JUMBO MINING CO.  
6305 Fern Spring Cove  
Austin, Texas 78730

M/027/007

RE: Reponse to Division's letter  
July 17, 1991-Review new heap  
pad permit application amend-  
ment at the Drum Mine

**MAP B - CLAY PIT DESIGN**

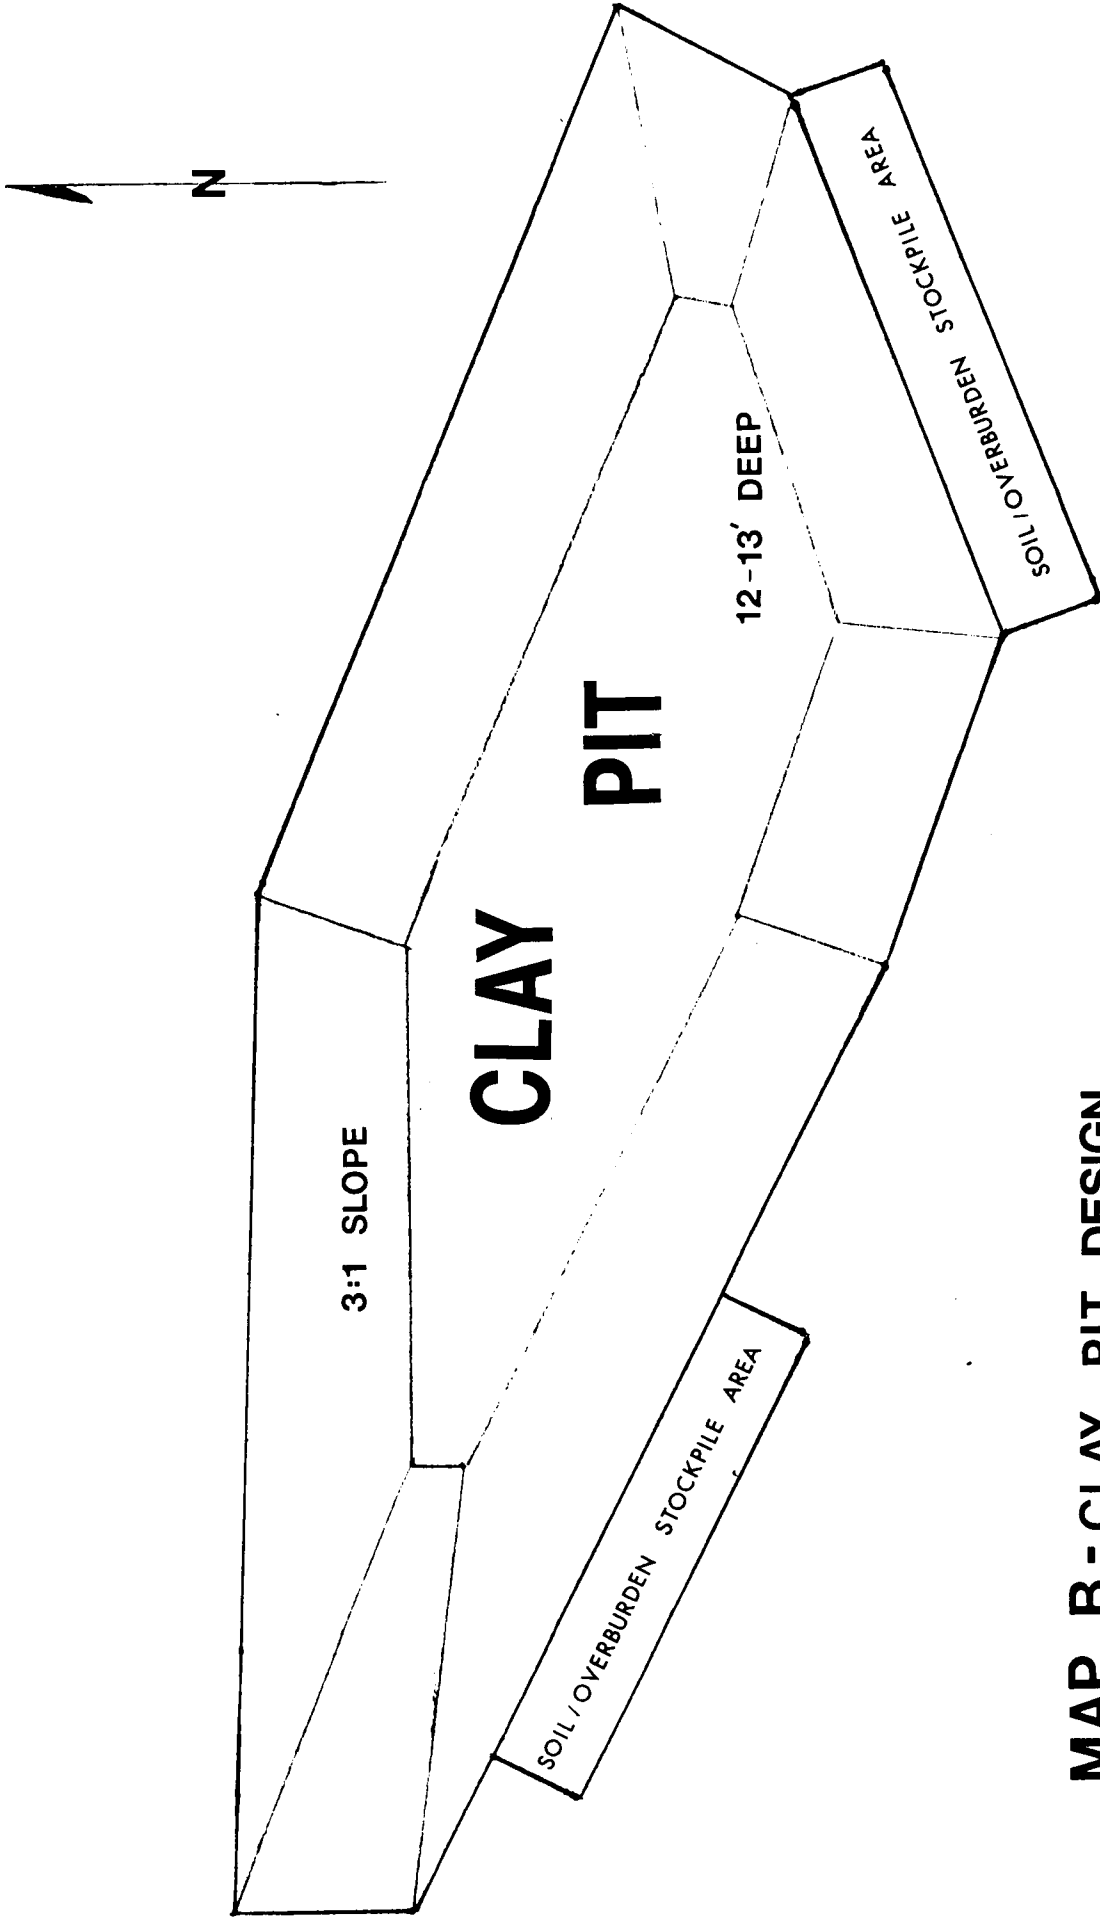
~ 7.2" DEEP 500' X 150'

DO THEY  
MEAN  
SPREADING  
TOPSOIL?

MAP C - DRAIN TRENCH

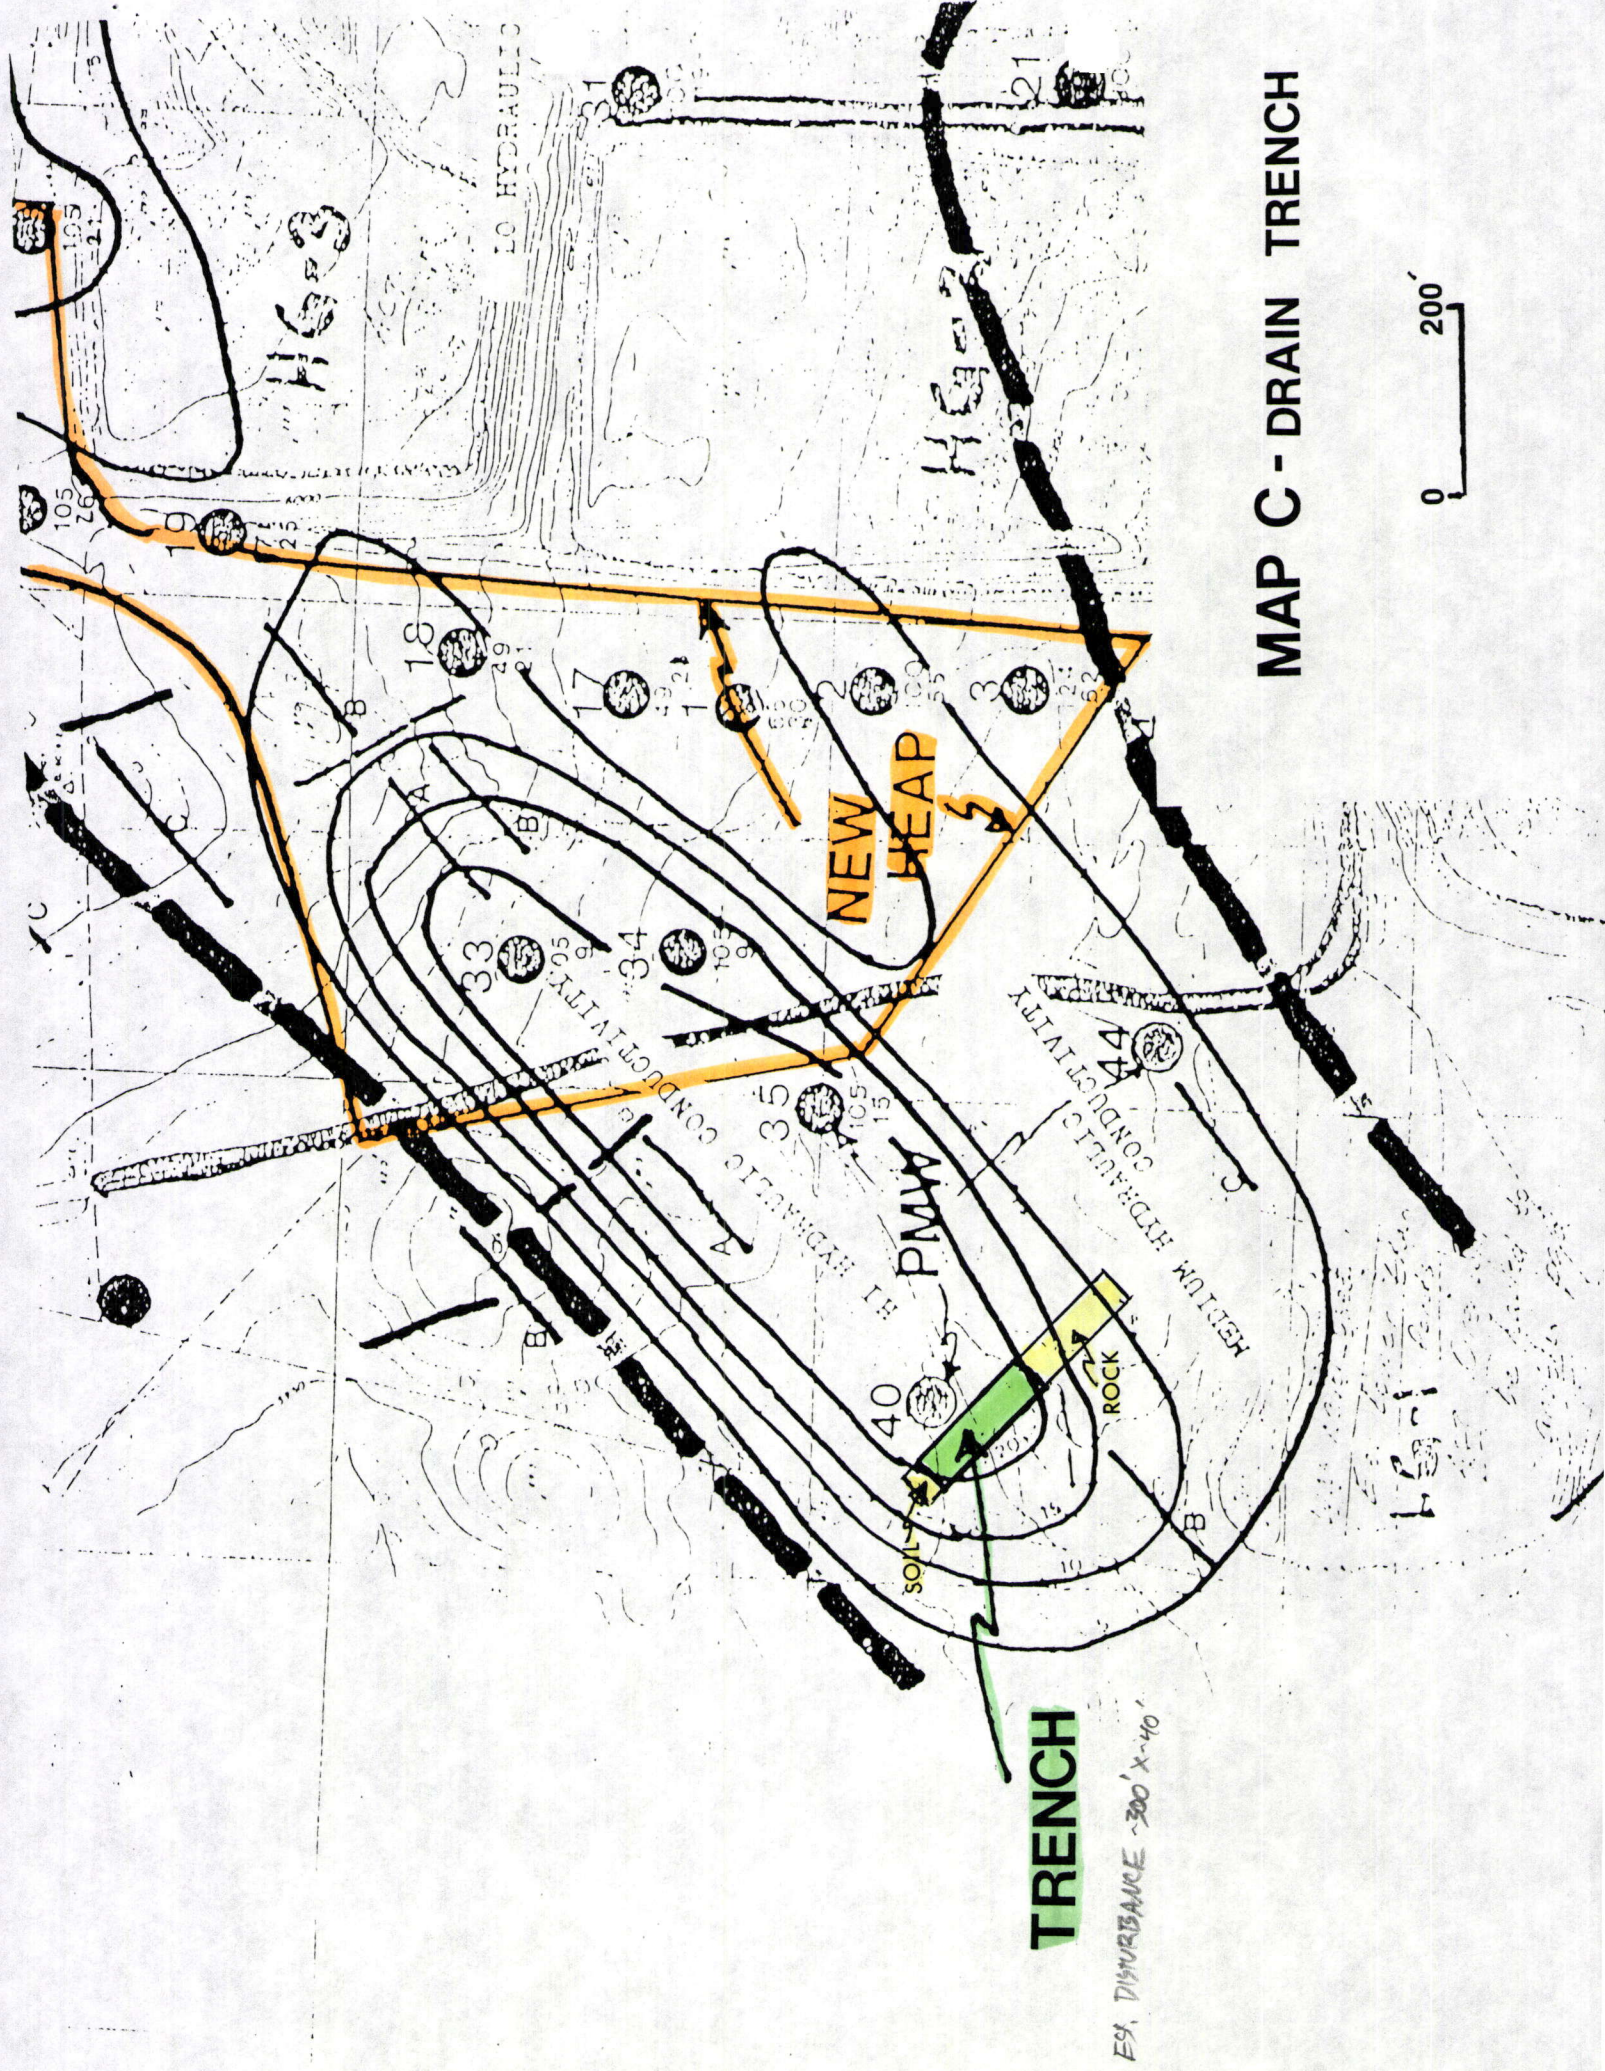
⇒ 1,333 CY MATERIAL

SEED/STABILIZE STOCKPILE?

FIG 5-1?
